ADDENDUM

ADDENDUM NO. 3

RE: New Bedford Marine Commerce Terminal
Phase 3 Bulkhead Replacement (Site 4)
Massachusetts Clean Energy Technology Center
Contract No. MACEC-FY26-02

PRECAST
PILE CAP
DETAIL 4 OF 7

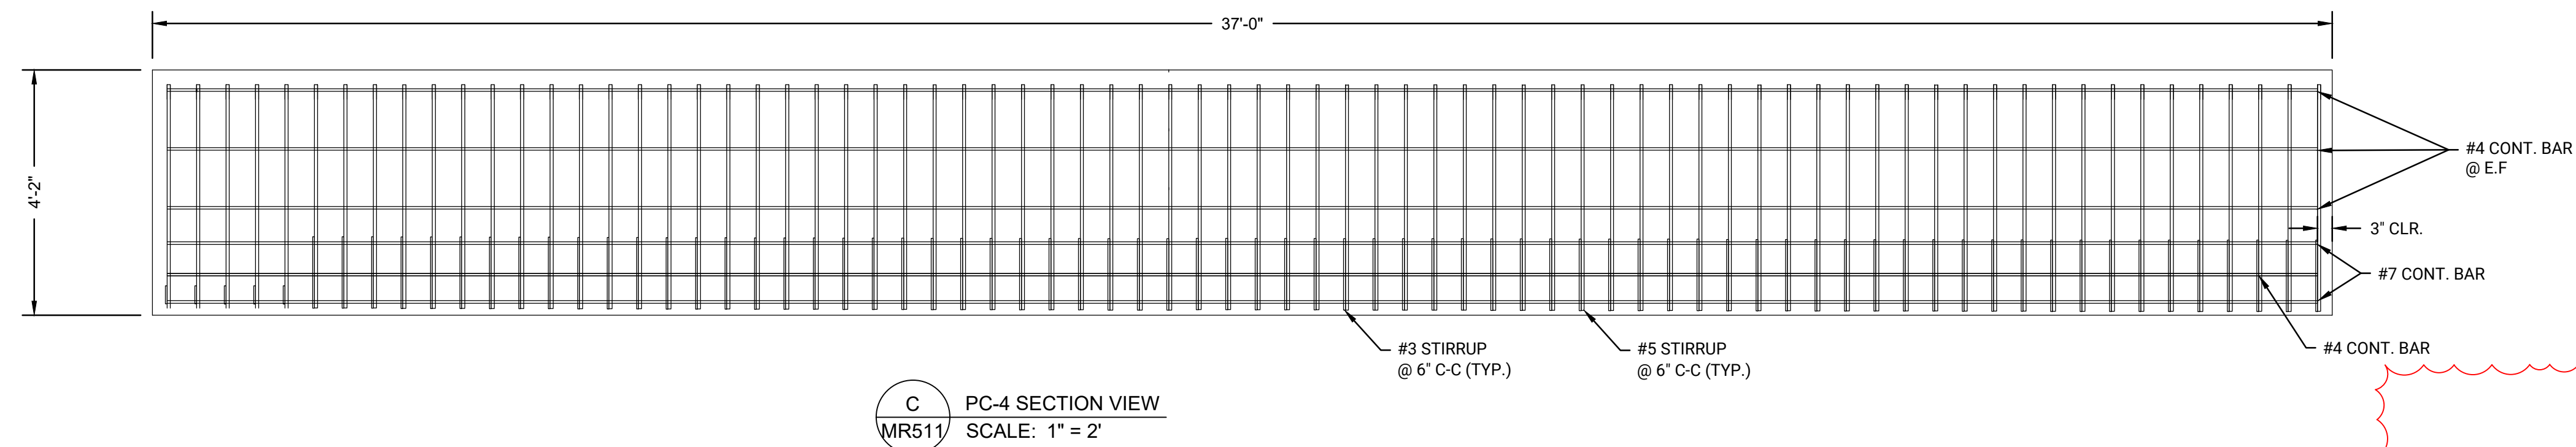
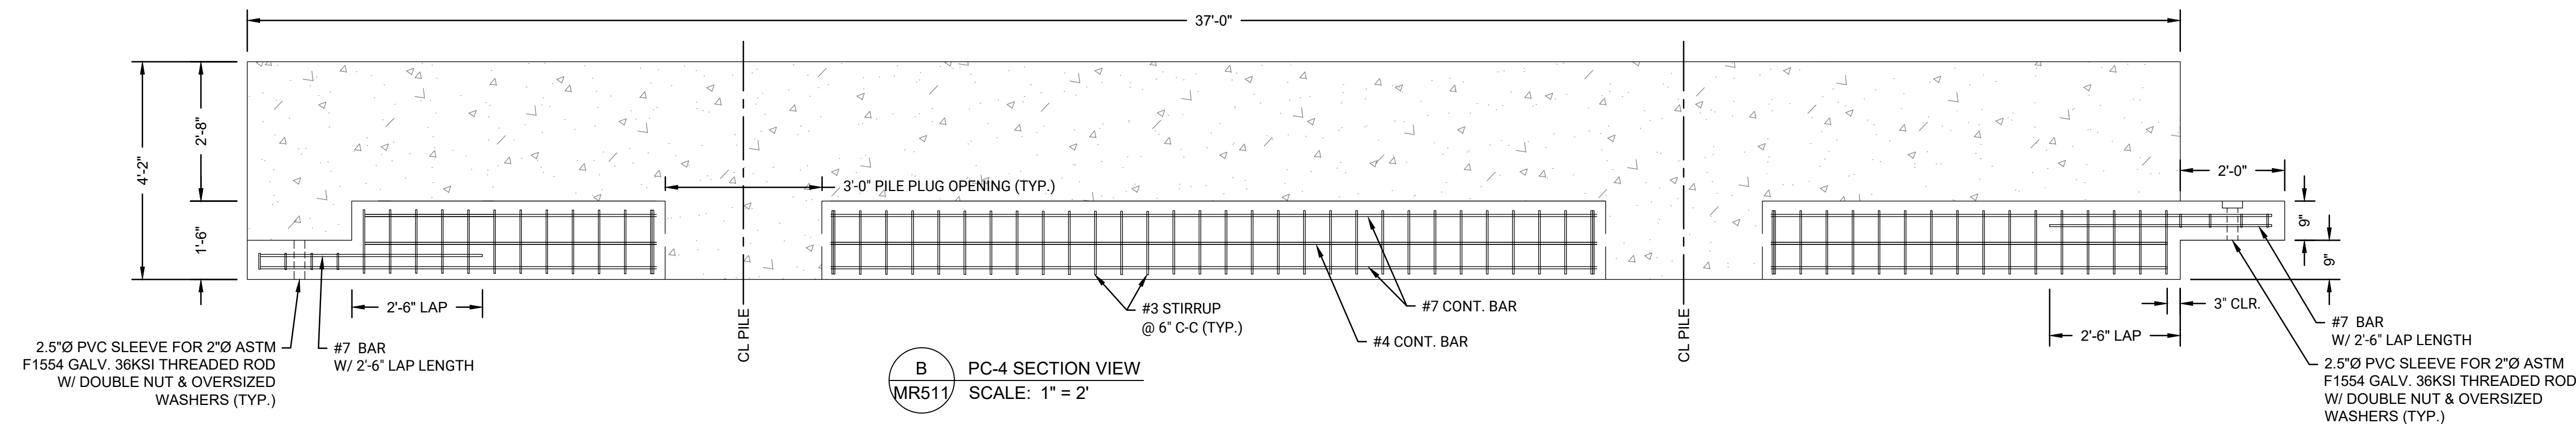
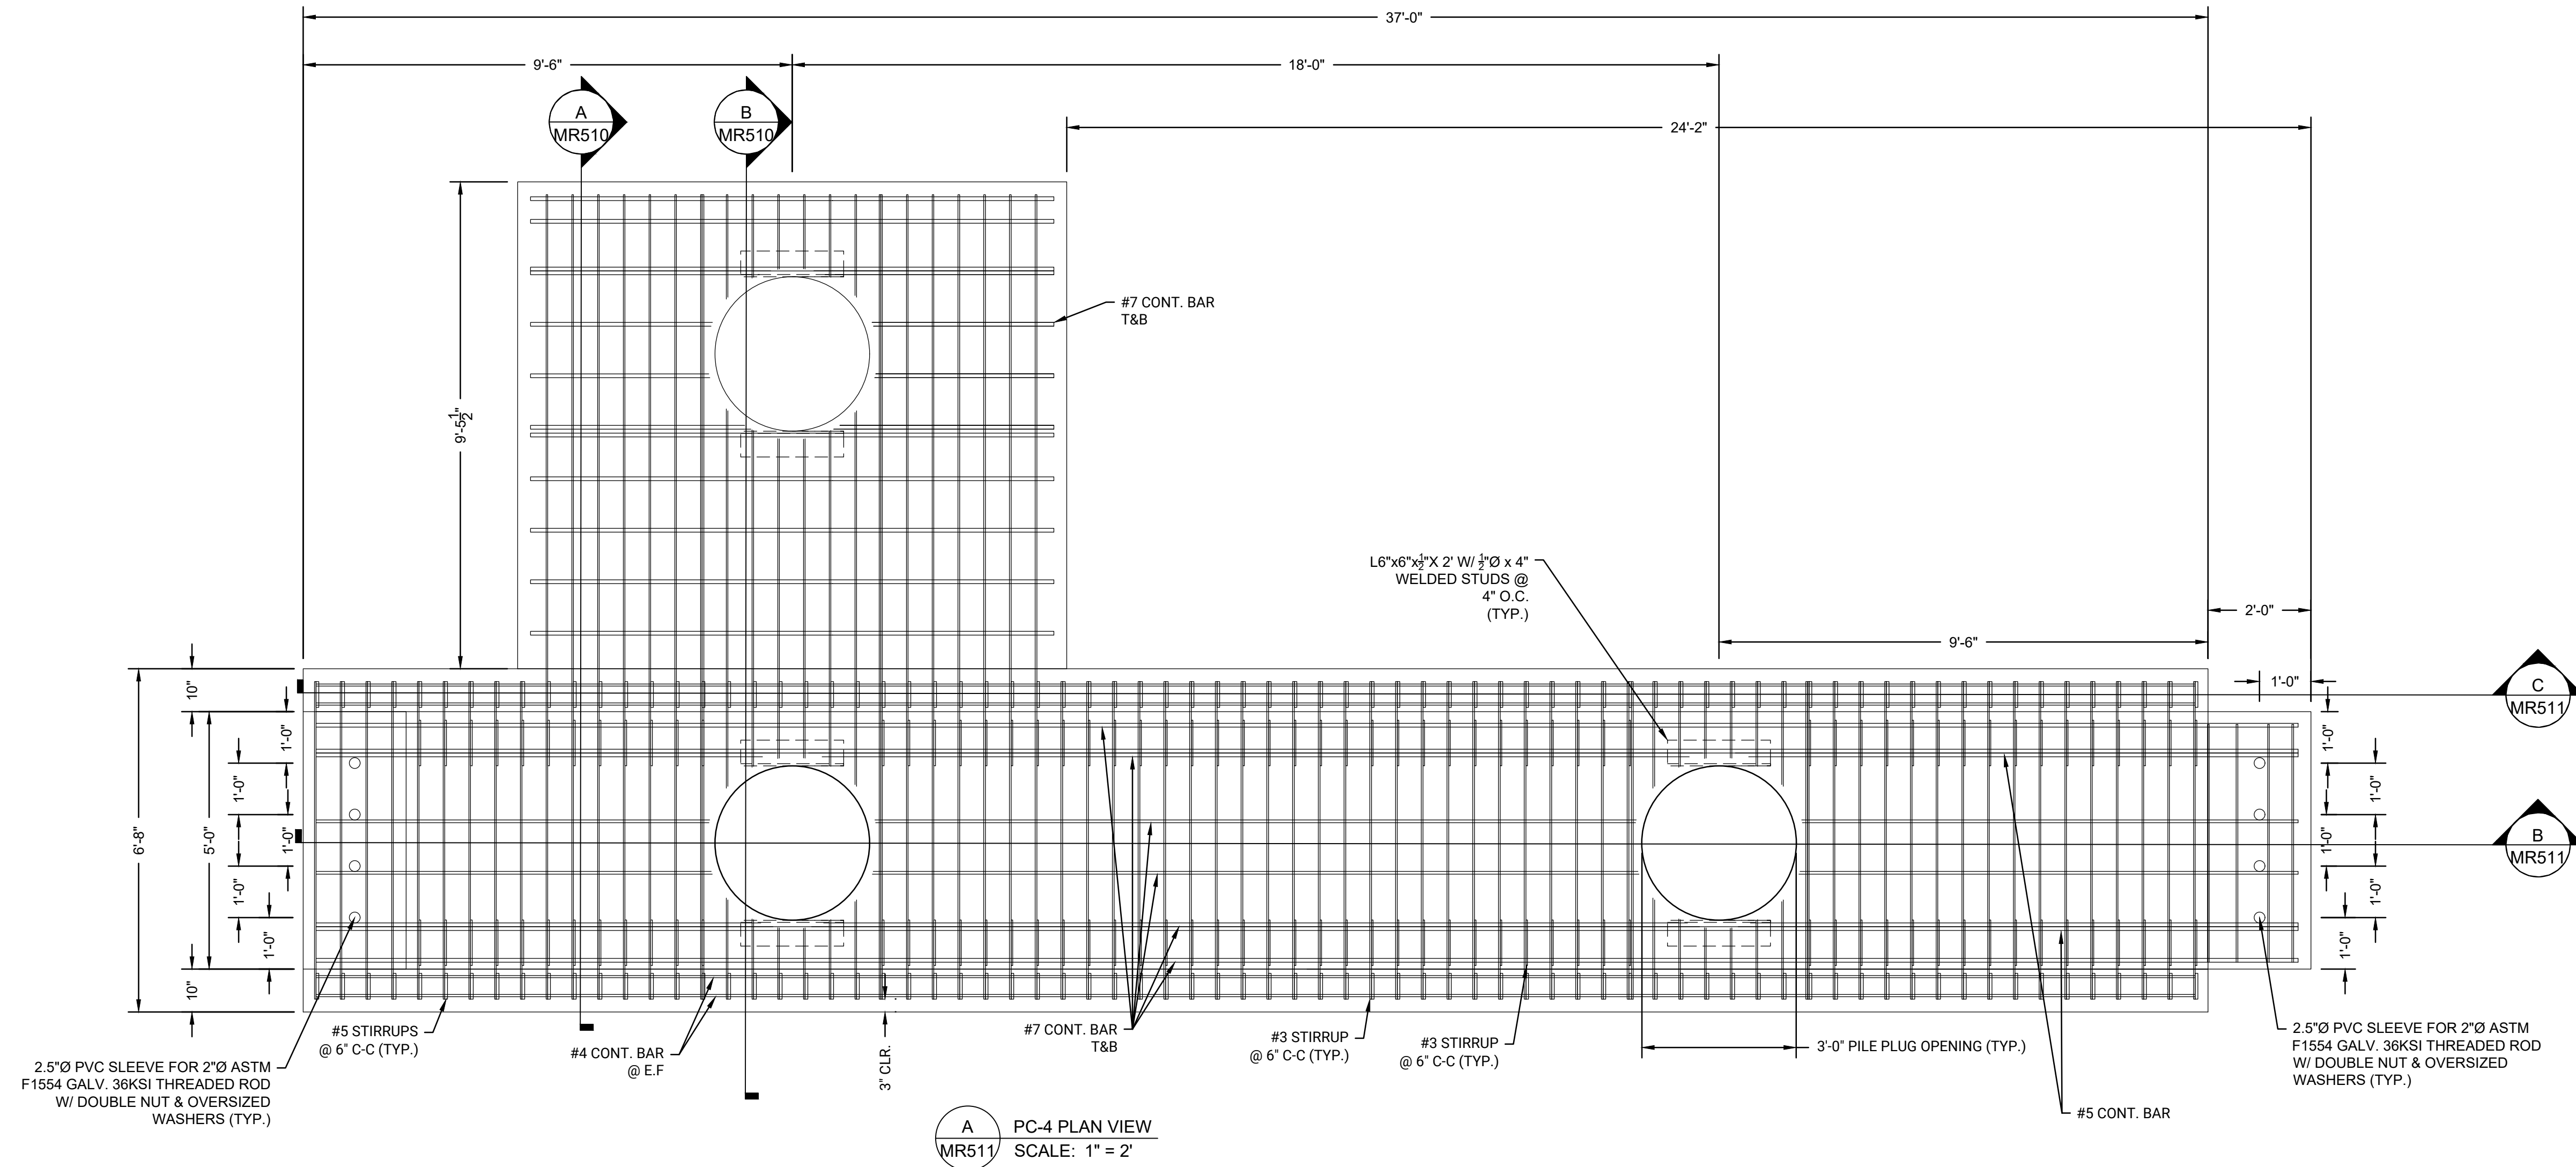
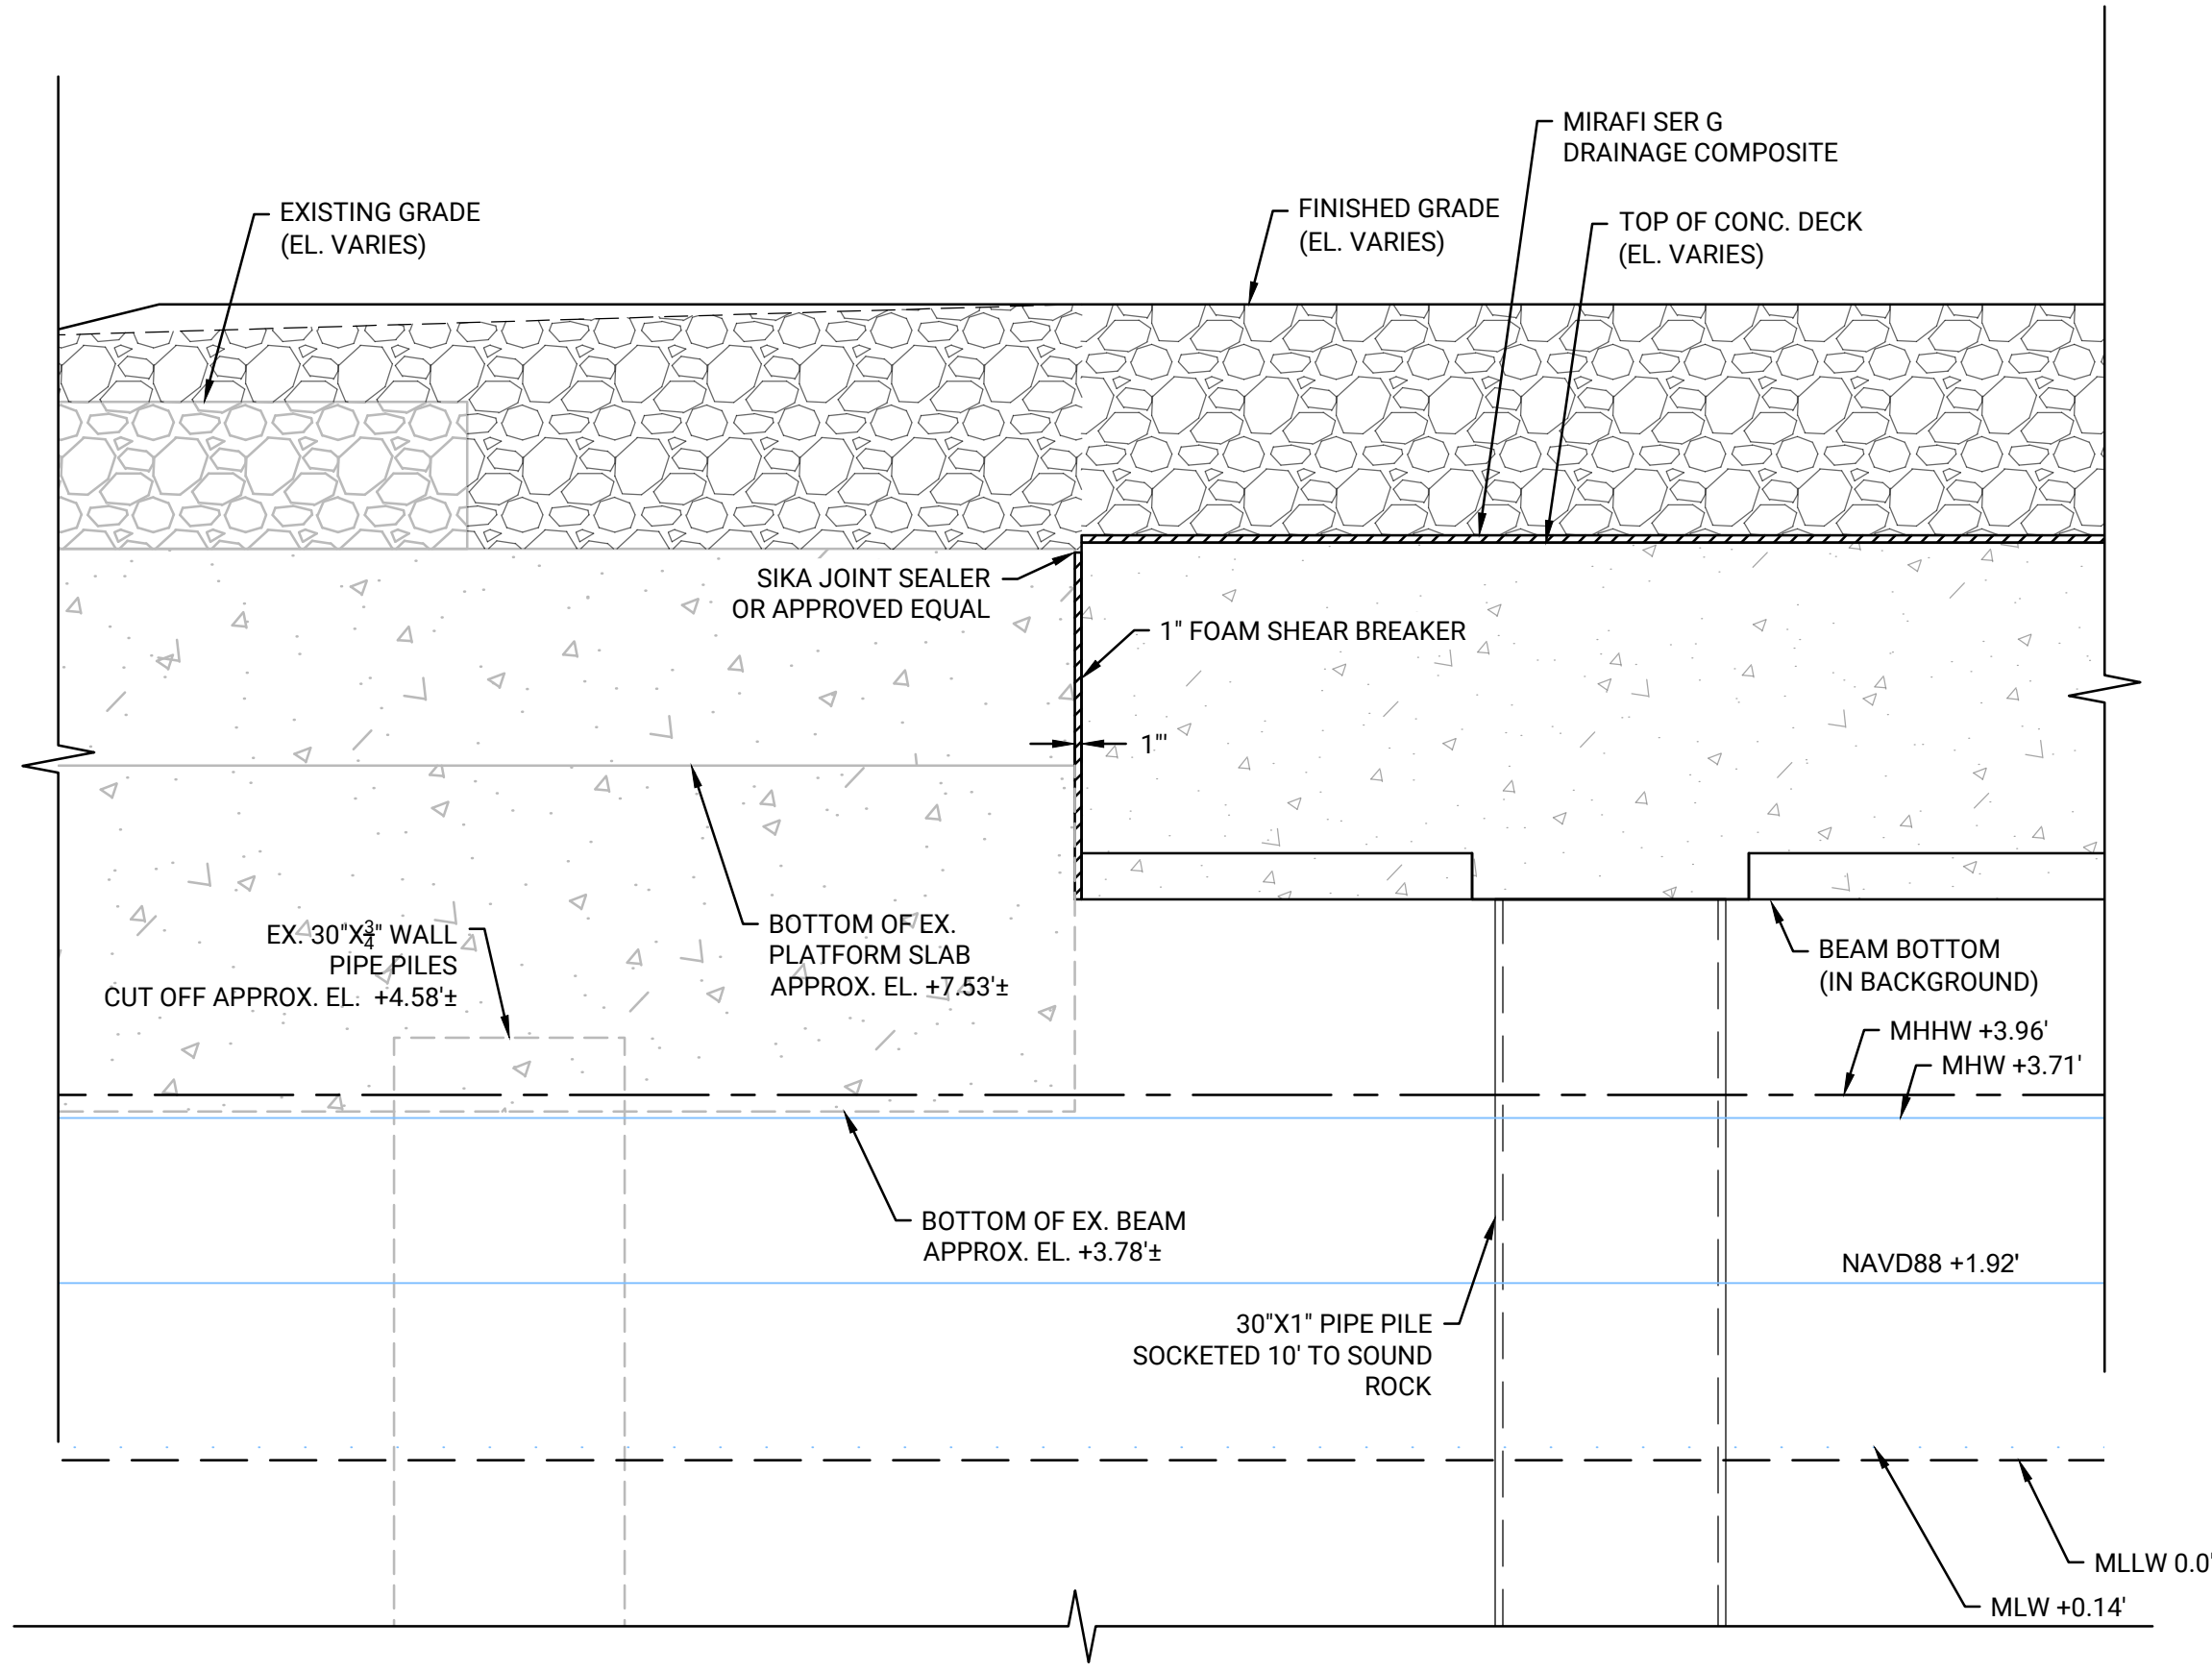
1. Drawings MR102 and MR508 through MR511 have been revised to reflect precast pile cap configuration addressing Question #2 (below). The revised Drawings are provided in **Attachment 1** to this Addendum No. 3.

1. Q: Will spiral weld pipe be acceptable?
A: YES, spiral weld pipe will be allowable steel pipe pile product.
2. Q: Are Pile Caps PC-1 to PC-8 connected to each other? If so, please provide a connections detail.
A: Please refer to the revised Drawings MR102 and MR508 through MR511, and the new Drawing MR511A. PC-1 through PC-6 have been resized and detailed to address precast pile cap connections.
3. Q: Please refer to the snapshot below from MR017. The red hatched area represents a gap between the proposed platform slab and existing Cofferdam cell which will be exposed to the open water below. Please provide a closure detail between the proposed platform slab and Cofferdam Cell to close this space.
